FCC ID: ALH378400

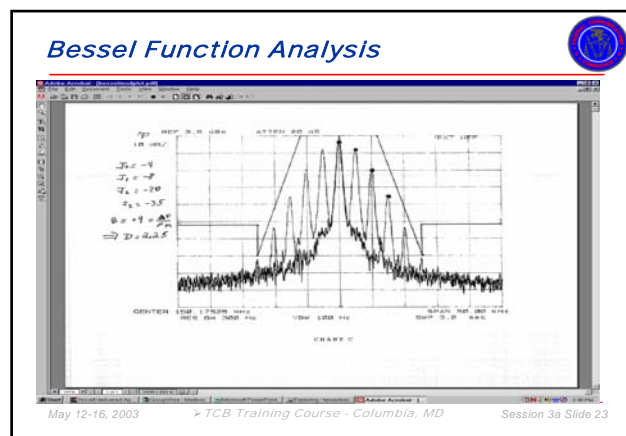
- 4) Radiated spurious emissions must follow substitution methods as specified by EIA/TIA 603. A test measurement procedure was not provided for this data nor reference to procedure used. Please update the report.
- 5) Regarding occupied bandwidth, normally a second trace is shown that shows that the top grat. line to show that the 0 dB reference is appropriately set to the total unmodulated carrier power (P). Please confirm or correct as necessary. As an example, note both traces for the following from FCC training:
